# Rezoning Transportation Analysis

Petition Number: 2022-210

## Revision Log:

Date	Description
05-24-2023	First Review (PDM)
06-21-2023	Second Review (DR)
08-23-2023	Third Review (PDM)
09-20-2023	Fourth Review (JP)

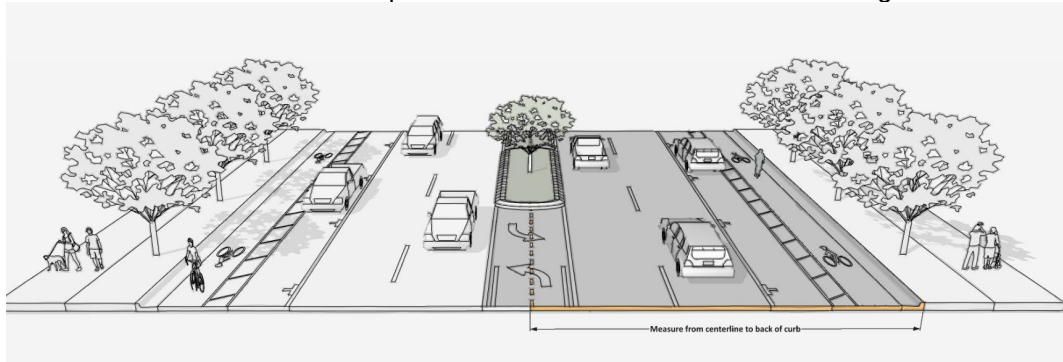
Petitioner to provide responses to the staff comments below as well as specify other changes to the site plan.

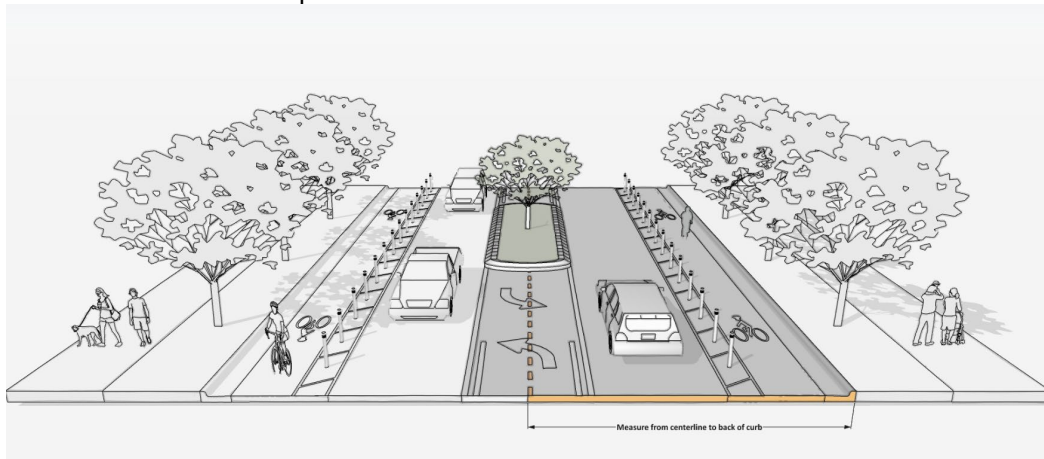
- a. **South Tryon Street:** Location of curb and gutter to be moved a minimum of 42.5 feet from roadway centerline to accommodate the Charlotte Streets Map with a roadway typical section of a 4+ Avenue with Buffered/Separated Bike Lanes and On-Street-Parking.

- b. **Clanton Road:** Location of curb and gutter to be moved a minimum of 27 feet from roadway centerline to accommodate the Charlotte Streets Map with a roadway typical section of a 2+ Avenue with Buffered/Separated Bike Lanes.

**NOTE: Additional distance from center line to back of curb may be required in locations where a median and turn lanes are required. Final curblines to be reviewed by CDOT once TIS is approved.**

**Outstanding Comment 9.20.23:** Label and dimension the curb and gutter from the centerline for each road on the site plan.

**Clarifying comment 6.21.23:** Label and dimension the curb and gutter from the centerline for Clanton Road and South Tryon Street.
